# TOWN OF OAK BLUFFS STREETSCAPE MASTER PLAN DESIGN PROJECT

## MASTER PLAN RECONCILIATION REFERENCE SHEETS

# STREETSCAPE DESIGN / MASTER PLAN RECONCILIATION

# STREETSCAPE DESIGN / MASTER PLAN RECONCILIATION CIRCUIT AVE TYPICAL CROSS SECTIONS

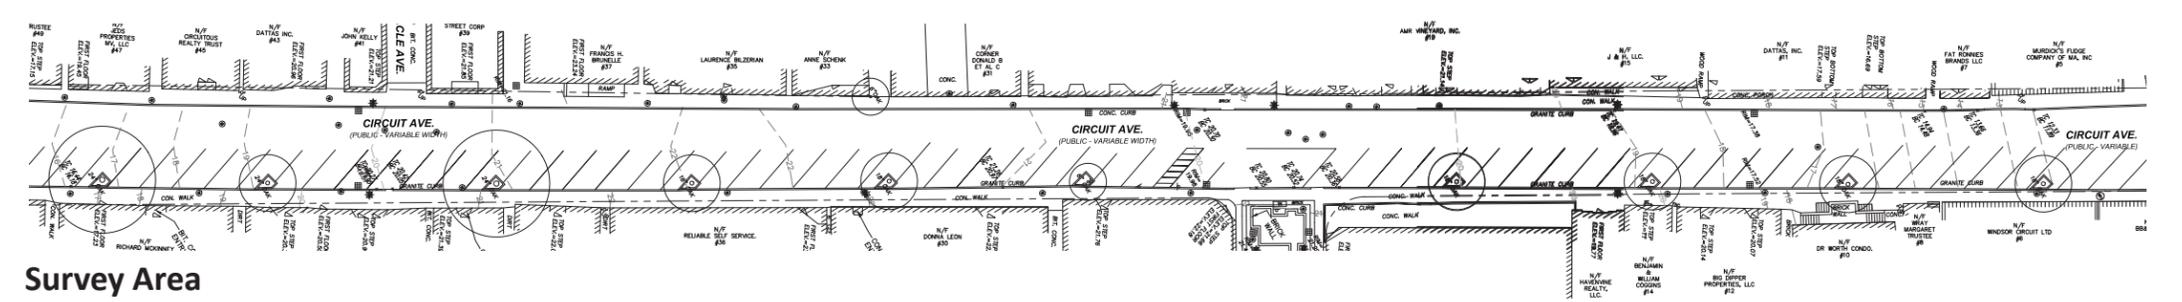
**Analysis**  
ROW is 40' wide between Lake Ave and Healey Plaza, then widens to 48' at Kennebec Ave intersection.  
16'W for angle parking is narrow. Actual width of travel at Section A would be less than the 11'W shown, with parked cars and trucks, since rear bumpers will stick out. Existing width of sidewalk from ROW line varies. Typical section sketch does not include width of curbs, so available width for sidewalk is 1' less than shown in sketch. In most parts of the west side the sidewalk is 5-6'W, so it would be narrowed if made 5'W.

**Recommendation**  
Because widths vary at different sections of Circuit Ave, we should make a concept sketch showing existing distances between the ROW line and the back of curb at various points on both sides of Circuit Ave. Draw concept sections (similar to those in the master plan, but including the curb) showing proposed widths at different parts of the street. Perform a vehicle turning study to see if standard cars can easily pull in and out of angle parking given the narrower travel lane. Redesign sections as needed.

Proposed Planter

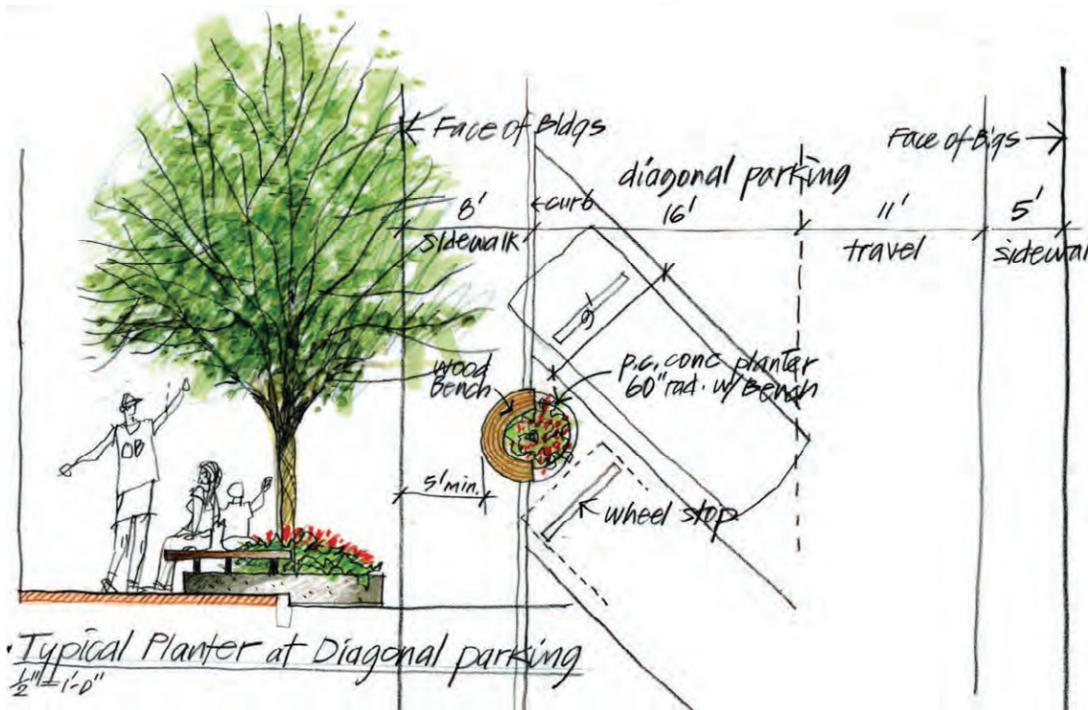
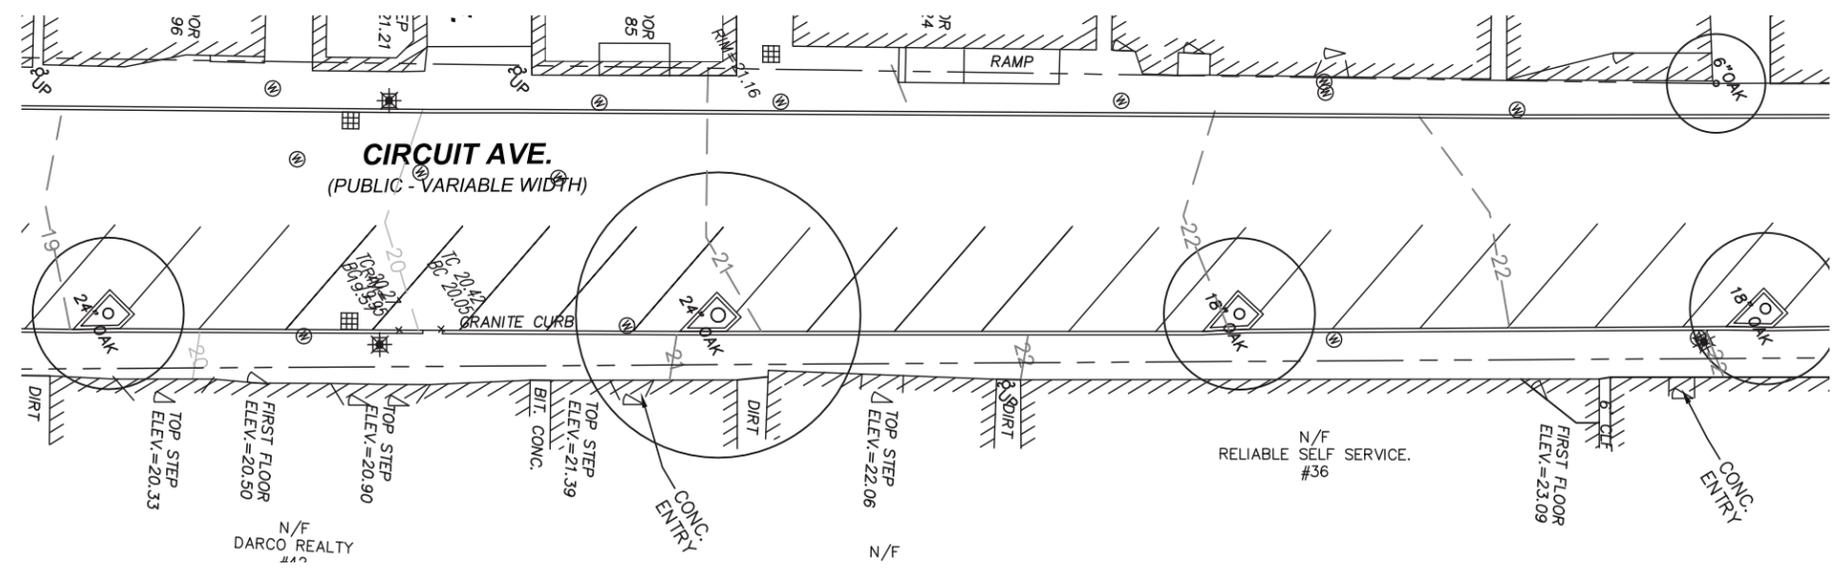
**Analysis**  
 Planter would be 5' diameter (not 5' radius). Existing street trees are oaks and callery pears.

**Recommendation**  
 Master plan concept sketch can be incorporated into DD design. Perform more comprehensive tree survey with landscape architect in spring/summer.

Concept Plan

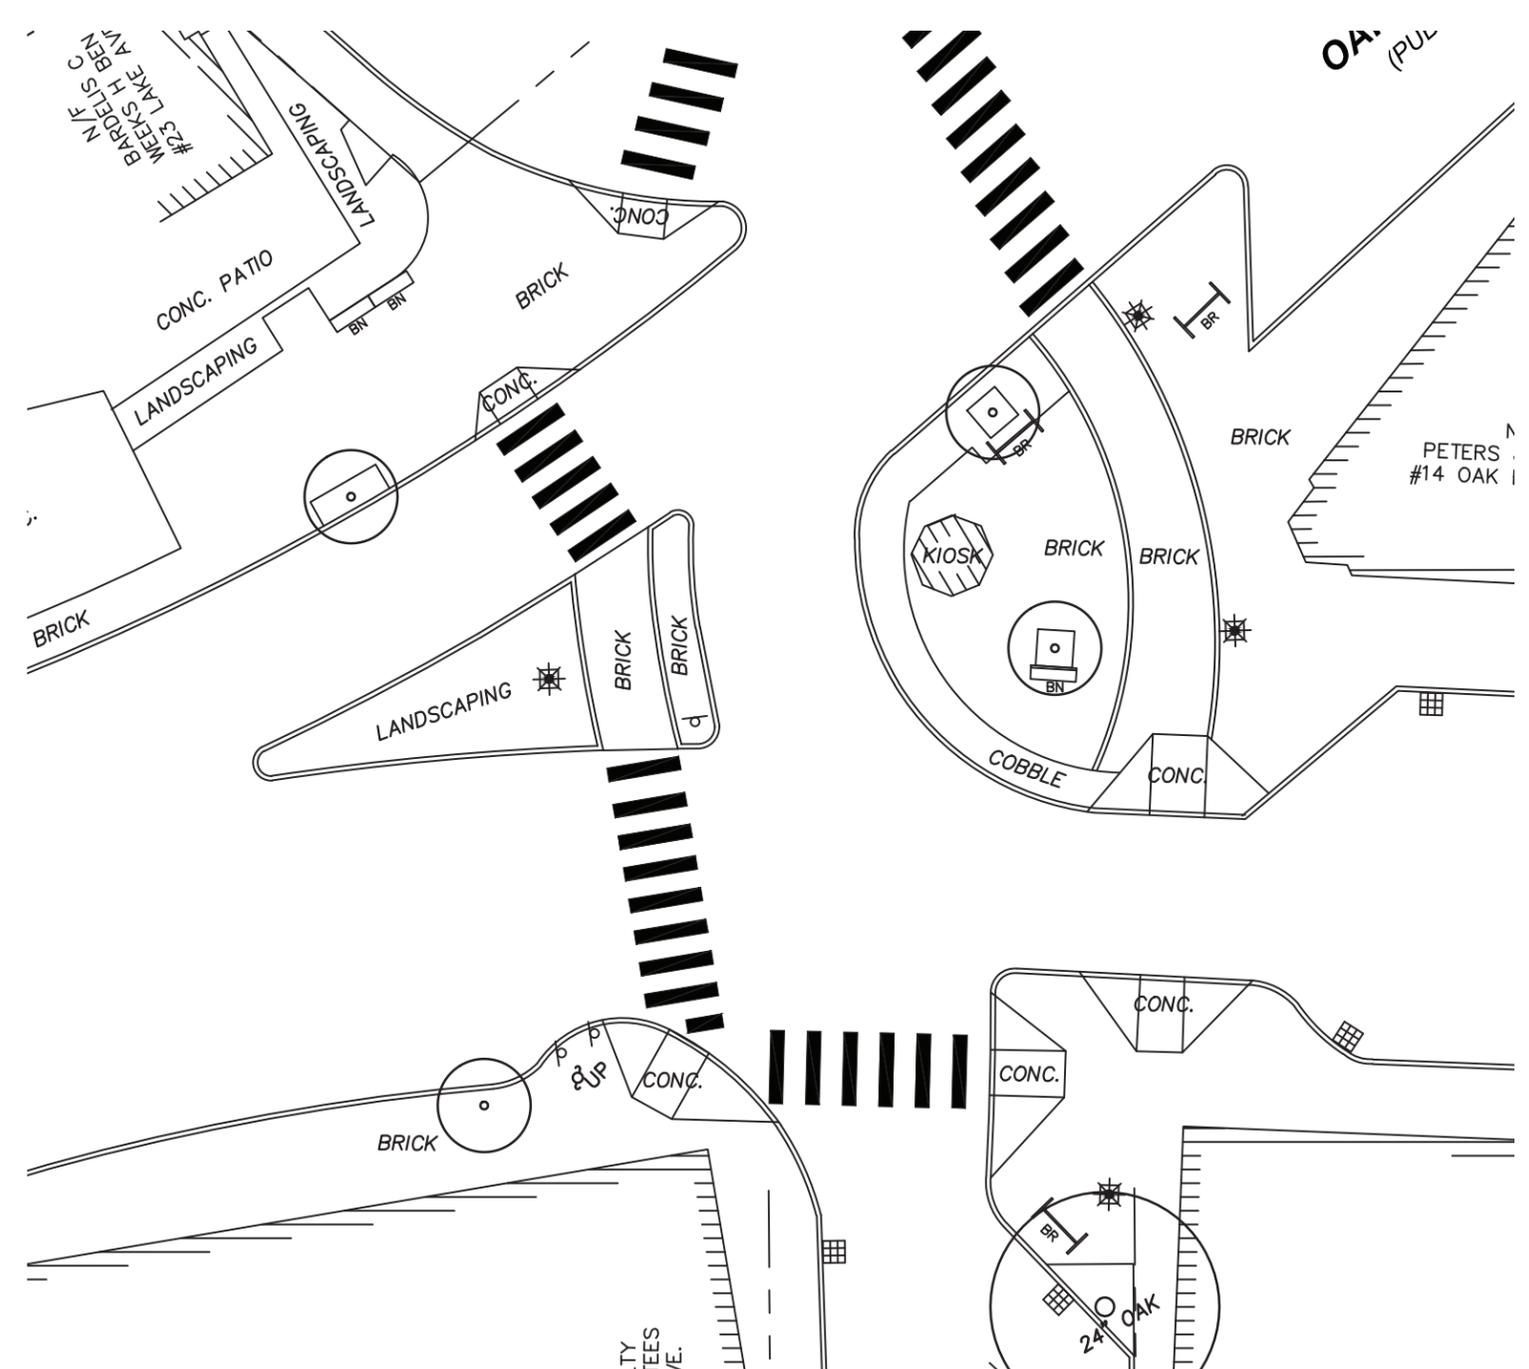
**Analysis**  
 Streetscape has already been renovated around Island Theater. Can implement special crosswalk paving, art, and landscaping in the intersection.

**Recommendation**  
 Master plan concept sketch can be incorporated into DD design.

# CIRCUIT AVE EXTENSION (HARBOR WAY) NORTH

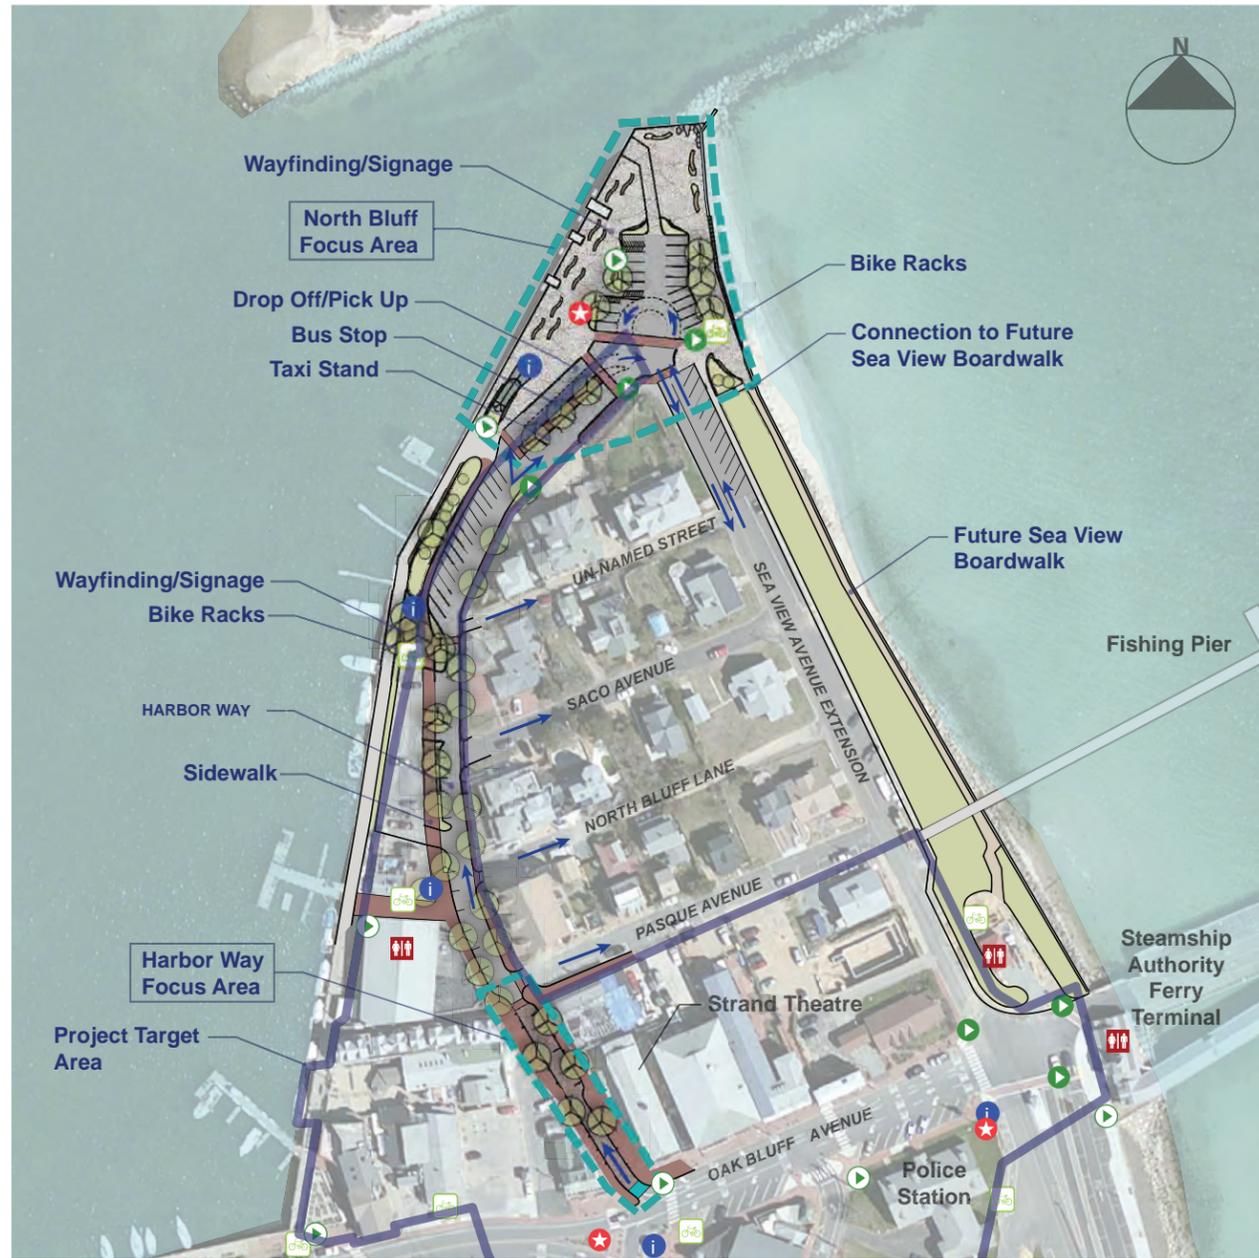
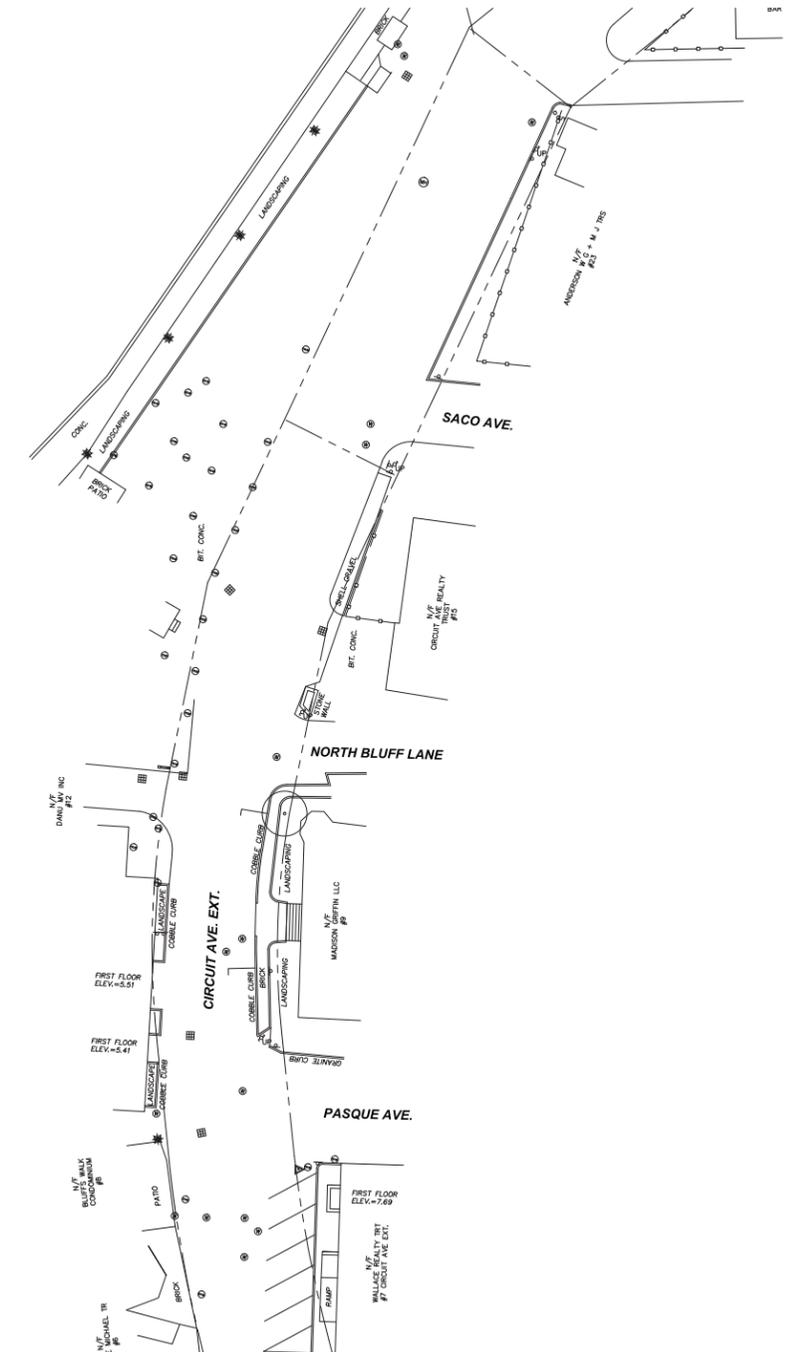
**Analysis**  
ROW has space for expanded sidewalks while maintaining parking and traffic lane.

**Recommendation**  
Master plan concept sketch can be incorporated into DD design.

# NORTH BLUFF PARK

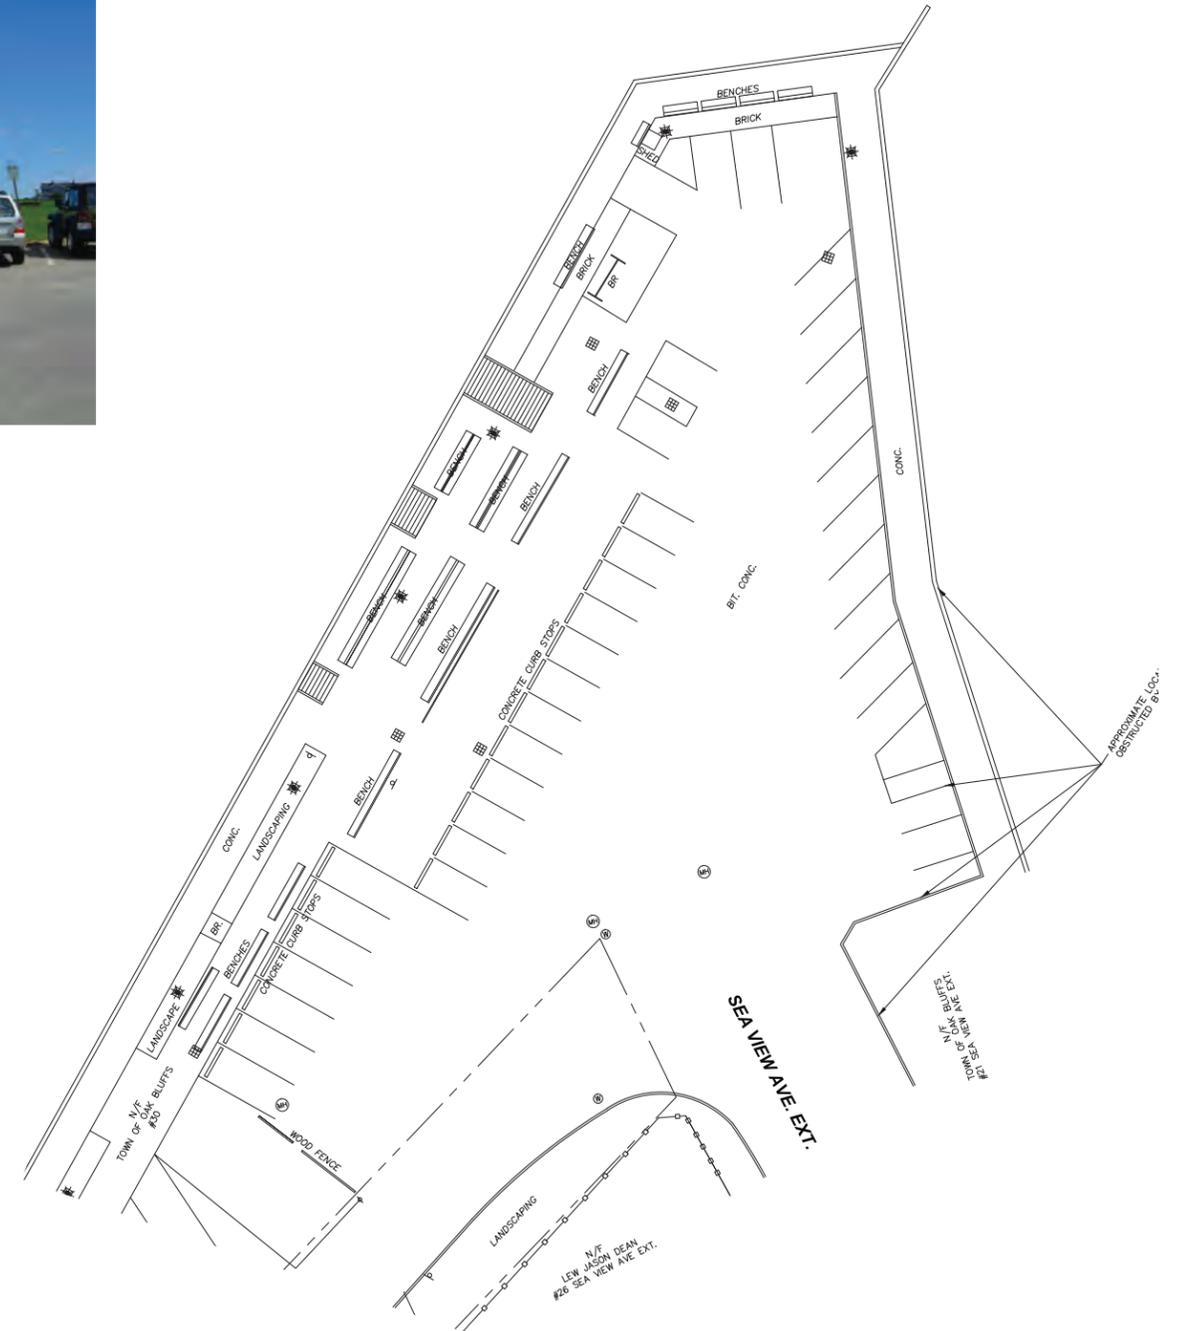
**Analysis**  
 Turnaround area in sketch is about 30' outside radius. **This is sufficient for passenger vehicles, but insufficient for commercial trucks.** (Current turning area is about 40' radius.) There is sufficient width for the bus and taxi stands.

**Recommendation**  
 Need to evaluate turning radius needs, and if needed draw a concept sketch of park with 40' radius turning area. Other elements of master plan sketch can be incorporated into DD design.

Concept Plan

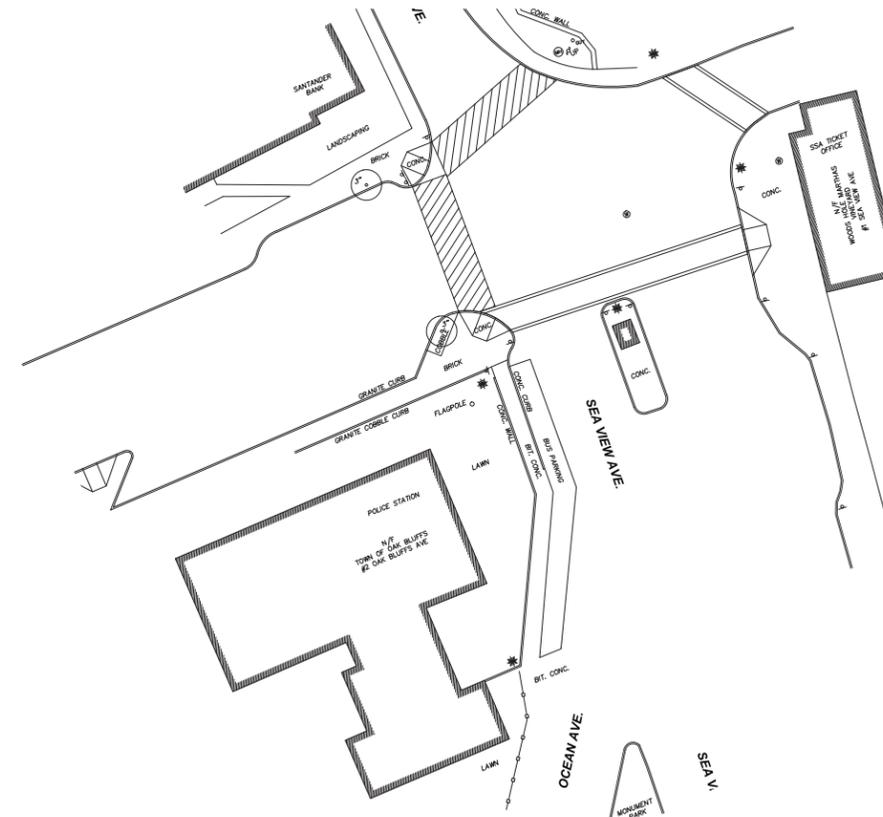
**Analysis**  
 Wayfinding can be placed outside SSA Ticket office and by police station. Paving around police station has been recently renovated- can add benches but difficult to expand plaza further. Should renovate sidewalk and landscaping on east side of police station and make crosswalk to monument park. **Relocating bus parking would impede traffic on Ocean Ave.**

**Recommendation**  
 DD Phase design should focus on wayfinding improvements and renovating the streetscape on the east side of the police station.
